802.3dj D2.2

Comment Resolution

Logic Track

Comment #366 and #374

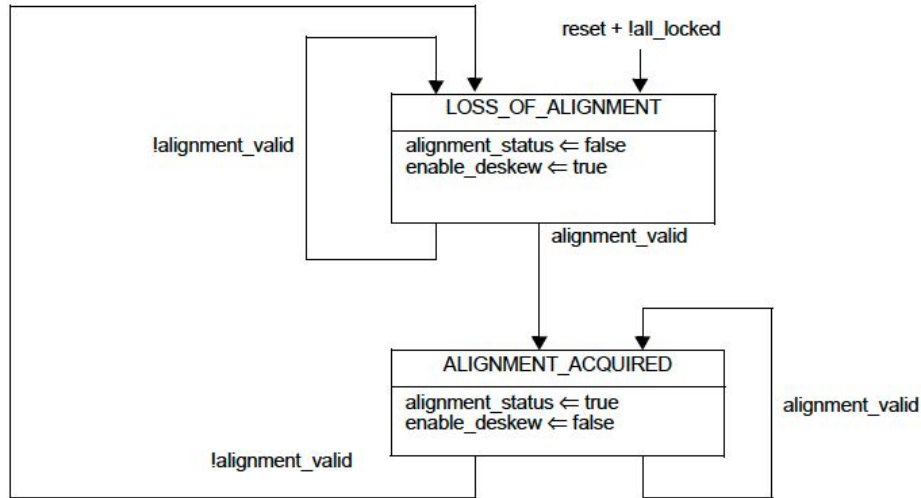
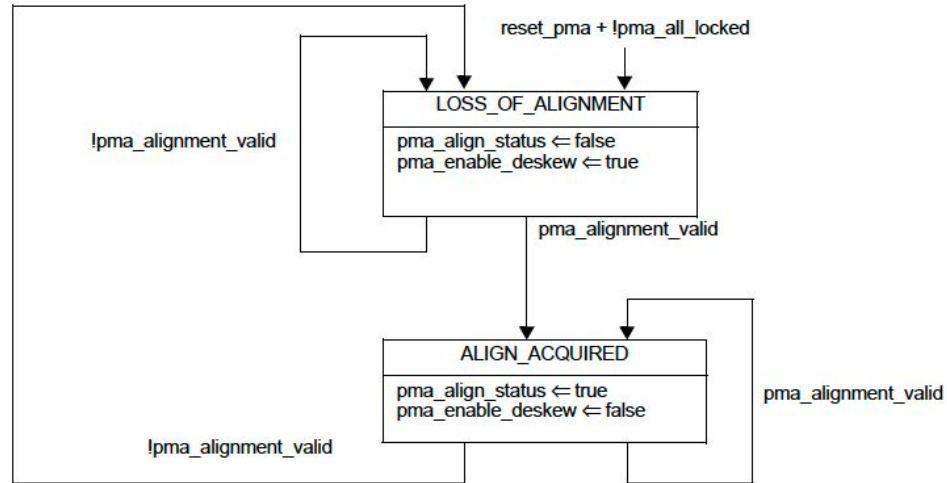
- In both state diagrams the value of `alignment_status` / `pma_align_status` is exactly the same as `alignment_valid` / `pma_alignment_valid`. The `[pma_]alignment_valid` variables have “complete” definitions, making the “status” variables unnecessary.
- The `enable_deskew` variables are set but never used.
- Both state machines do not add information in a meaningful way and can be removed.

- Remove Figure 184-10 and all references to it.
- In 184.7.3:

- Remove Figure 186-18 and all references to it.
- In 186.4.3:
~~The 800GBASE-ER1 PMA shall also implement the deskew process as shown in Figure 186-18.~~
- Delete unused variables in 186.4.2.1 variable definitions:
 - pma_align_status
 - pma_all_locked
 - pma_enable_deskew
- Update text in 186.3.4.3 to clarify the deskew process.

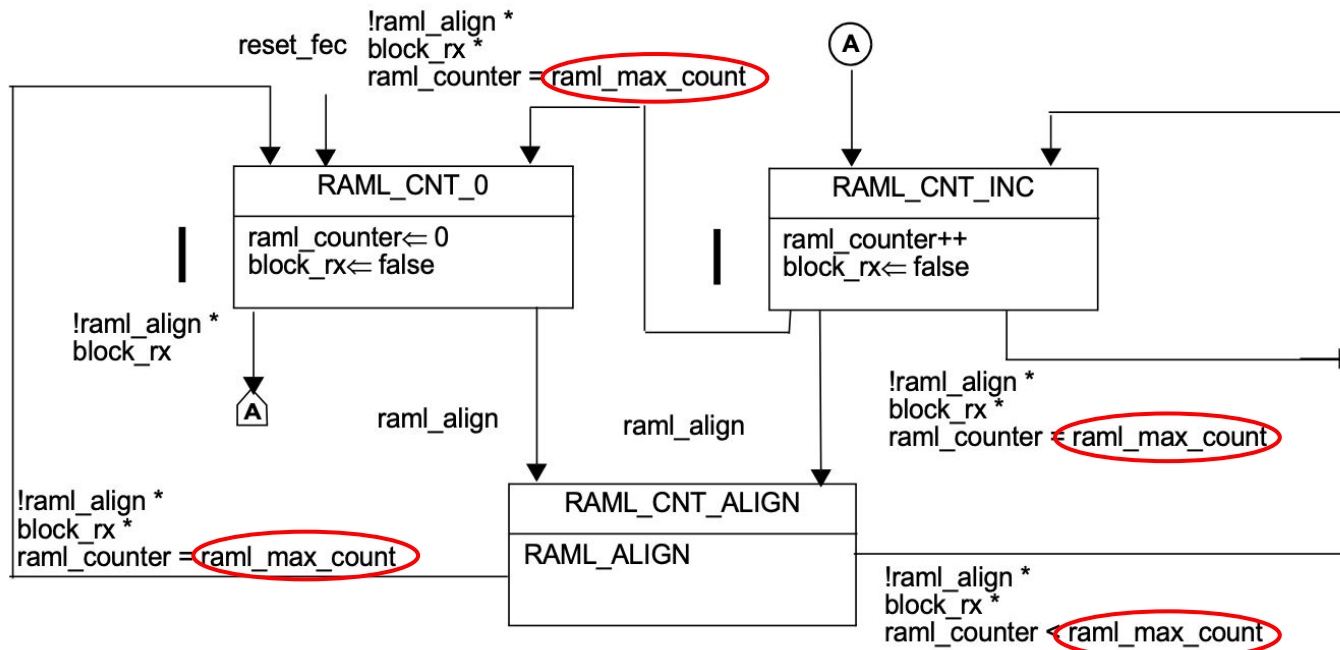
The definition of raml_max_count says it indicates a number of 257-bit blocks between alignment markers. This variable is used in state diagram figure 186-21 in comparisons to raml_counter, but it is never set to any value in any of the state diagrams or in text. How is its value actually set?

- Step 1: Remove the above variable definition and add a new Constant definition in a new 186.4.2.1 “Constants” subclause (pushing the “Variables” subclause to 186.4.2.2):

`AM_INTERVAL`

The number of 257-bit blocks between alignment markers. For 800GBASE-R it is set to 327 664.

- Step 2: Replace the variable `raml_max_count` with the constant `AM_INTERVAL` in Figure 186-21.

Figure 186-19—800GBASE-ER1 FEC sublayer FAM field lock state diagram

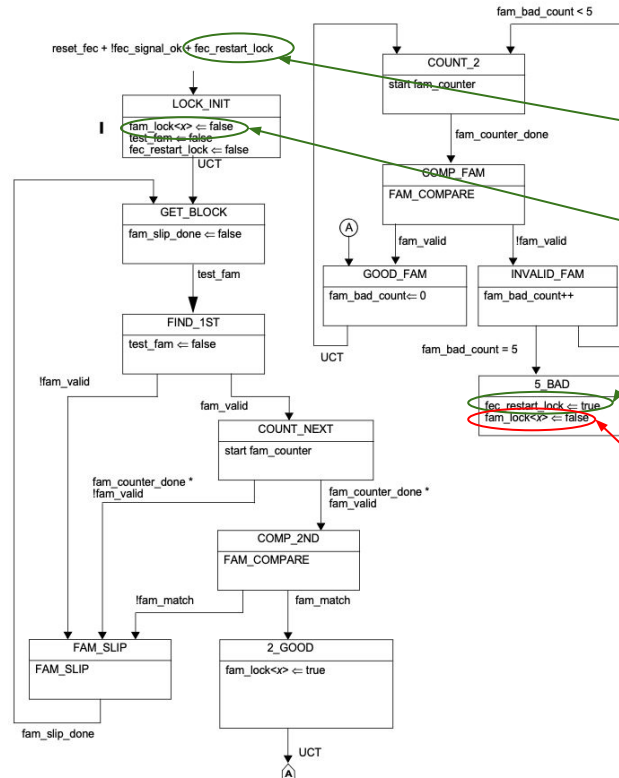
(1) Setting fec_restart_lock to true in 5_BAD state causes all 8 instances of this state diagram to restart the lock process.

(2) Each of the 8 instances resets fam_lock<x> to false in the LOCK_INIT state

Setting fam_lock<x> to false in the 5_BAD state is redundant and a little misleading.

Remove this line from 5_BAD.

Figure 186-17—800GBASE-ER1 PMA FAW field lock state diagram

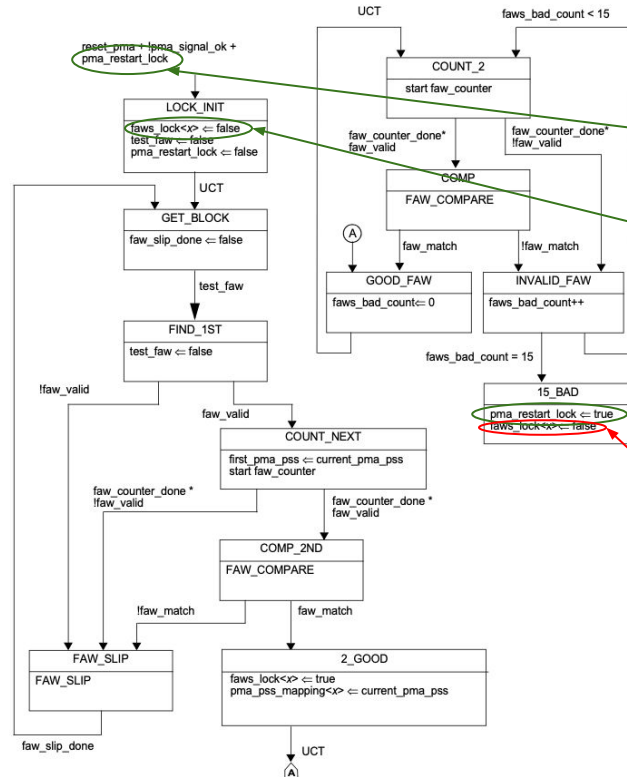
(1) Setting pma_restart_lock to true in 15_BAD state causes all 8 instances of this state diagram to restart the lock process.

(2) Each of the 8 instances resets faws_lock<x> to false in the LOCK_INIT state

Setting faws_lock<x> to false in the 15_BAD state is redundant and a little misleading.

Remove this line from 15_BAD.

Figure 186–20—800GBASE-ER1 FEC sublayer multi-frame alignment state diagram

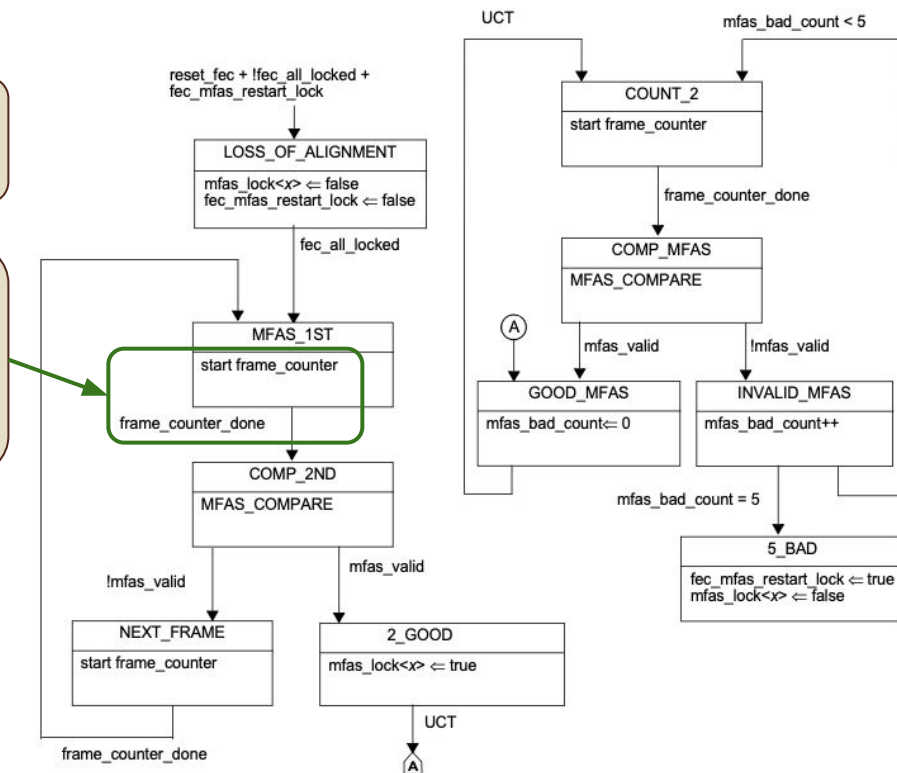
There are 8 instances of the Fig. 186-20 state diagram process.

Each instance has a “frame_counter<x>”

Comment #385 will update “frame_counter” to “frame_counter<x>” in this state diagram.

Figure 186-21—800GBASE-ER1 FEC sublayer alignment marker location state diagram

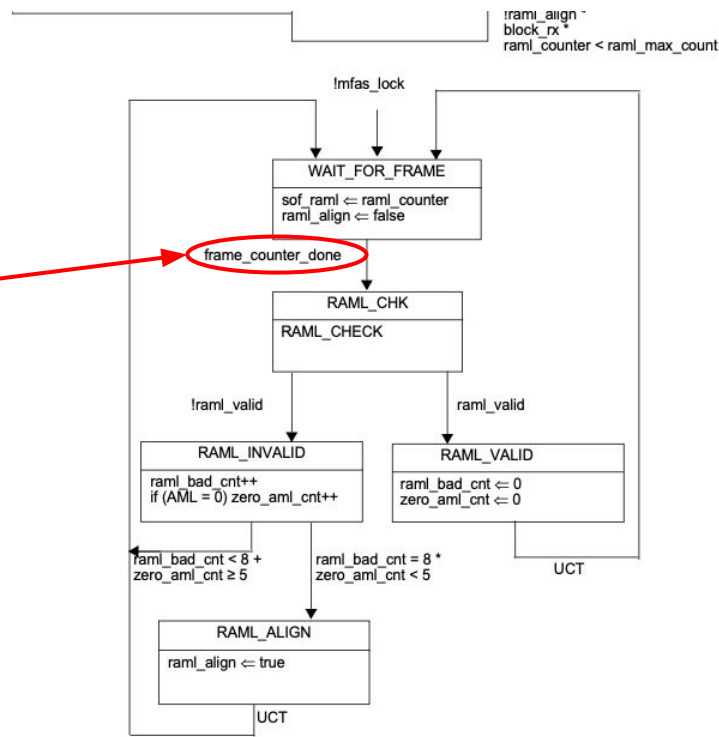
| In the state diagram in Figure 186-21, the transition from state WAIT_FOR_FRAME to RAML_CHK is made when frame_counter_done is true. However, this counter is started in a different state diagram and it is very hard to tell how this is working since there are 8 instances of that other state diagram. It would be easier to follow if there were a separate counter for this state diagram that is started locally, and then wait for done and then reset the done variable in the next state. | | | | |

Change frame_counter_done to multiframe_count_done.

Add new counter multiframe_counter (with editorial license).

Figure 177-n—PRBS13 scrambler

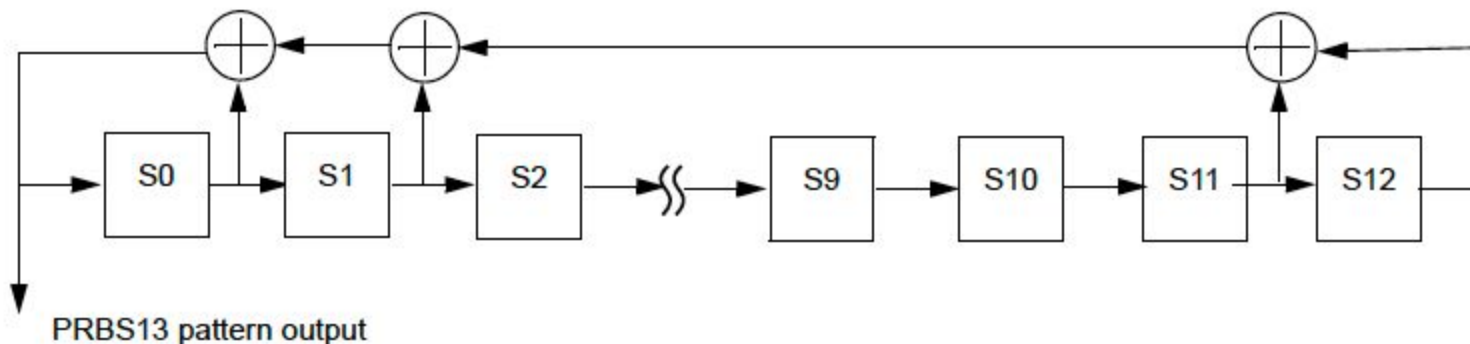
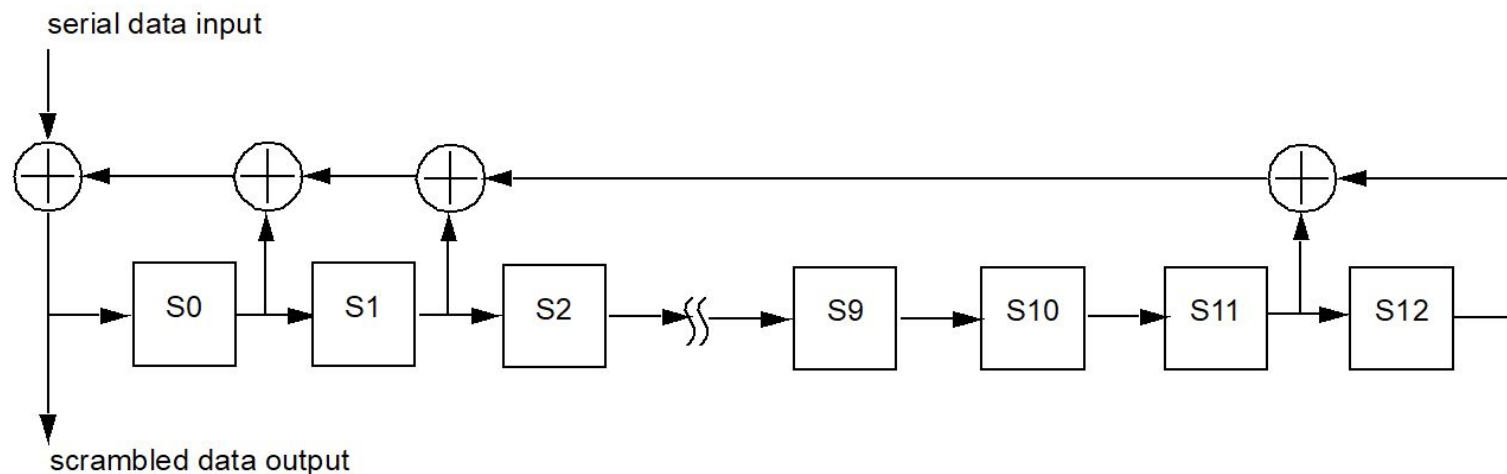
- 177.4.7.2 defines a 13-bit scrambler with a reference to Figure 94-6 and Equation 94-3.

- Figure 94-6 is a PRBS13 generator, and needs to be modified slightly to be a self-sync scrambler

- Add a new figure to 177.4.7.2, based on Figure 94-6, but adding the data input.

Figure 175-8—PCS synchronization state diagram

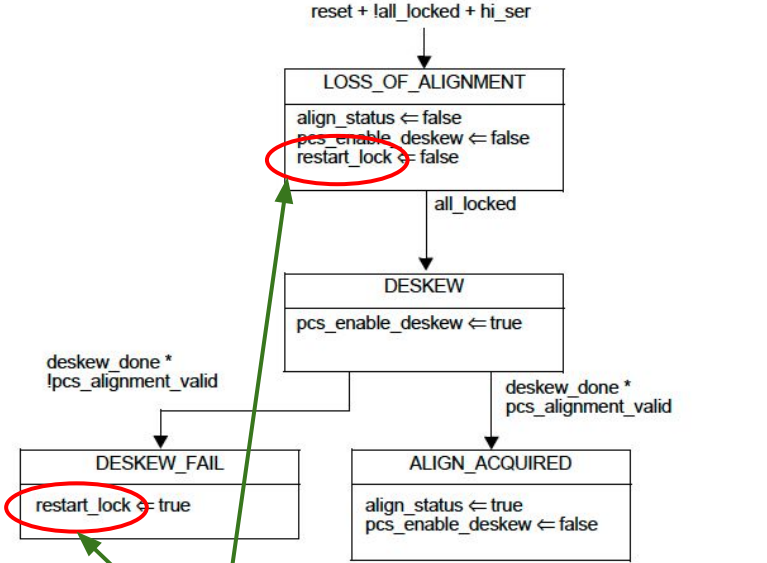
1. Two separate variables with same basic name (one is indexed) should be renamed to remove any confusion between them.
2. Restart_lock can be set to true by both a state diagram and by its own definition when another variable (restart_lock<z>) is set to true in a different state diagram.

Change to “deskew_failed”
